ADMINISTRATIVE SHORT PLAT REPORT & DECISION

REPORT DATE:	March 31, 2015
Project Name:	Nantucket Short Plat
Project Number:	LUA14-001272; SHPL-A
Project Manager:	Kris Sorensen, Associate Planner
Owner:	Nantucket Avenue, LLC; 2812 257 th Pl SE; Sammamish, WA 98075
Applicant/Contact:	Darrell Offe; Offe Engineers; 13932 SE 159 th Pl; Renton, WA 98058
Project Location:	2802 and 2820 Park Ave N

01/28/2015
 NANTUCKET AVENUE PLAT
 NANTUCKET AVENUE, LLC
 TREE RETENTION PLAN
 2820 PARK AVENUE NORTH

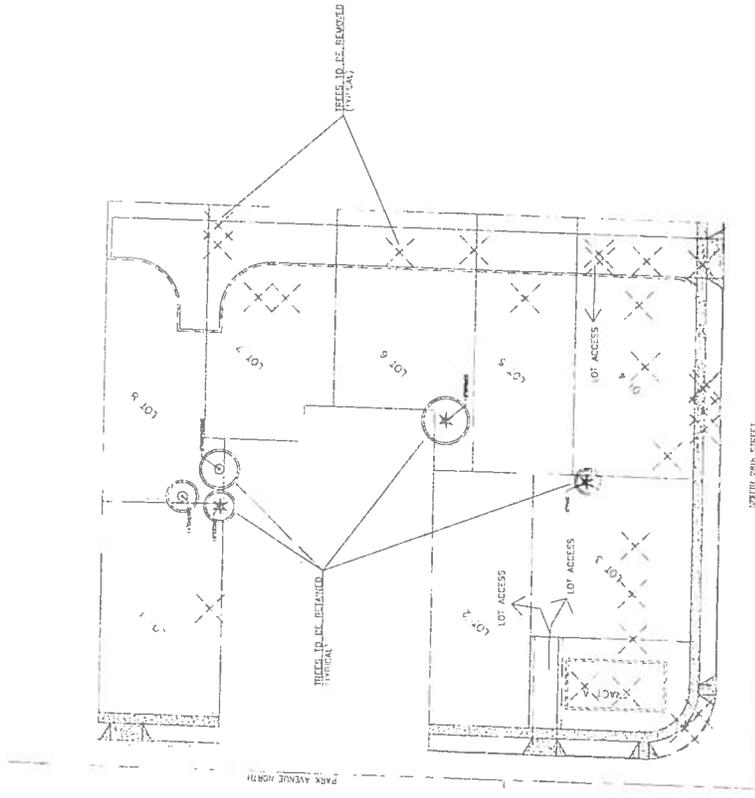
<p>✓</p>	<p>Tree Retention: Existing trees shall be retained where feasible. RMC 4-4-130 requires 30 percent of trees to be retained. If the required number of trees cannot be retained, they must be replaced according to RMC 4-4-130H.</p> <p>Staff Comment: <i>According to the Tree Retention Worksheet and Tree Inventory there are 37 significant trees with 6-inch diameter or greater on the site (Exhibits 5 and 8). Fourteen trees would be excluded from retention requirements due to their location within the areas where street right-of-way and the private street are to be developed.</i></p> <p><i>The Tree retention standards require a minimum of 30 percent of the trees after deduction which is 23 trees; which requires 7 on-site trees to be retained or replaced. The applicant is proposing to retain 5 trees, including Spruce, Pine, Cedar, Cherry, and Hawthorne species. To replace the 2 trees that cannot be retained, the applicant must provide 8 replacement trees where the applicant proposes to install a total of 29 new trees all 3 inches in caliper (Exhibit 4). Trees would be planted in front yards of each lot, between the easterly neighboring property and the private street, and within the public street planter strips. Based on the provided landscape plan the applicant has complied with the tree retention standards of the code.</i></p>
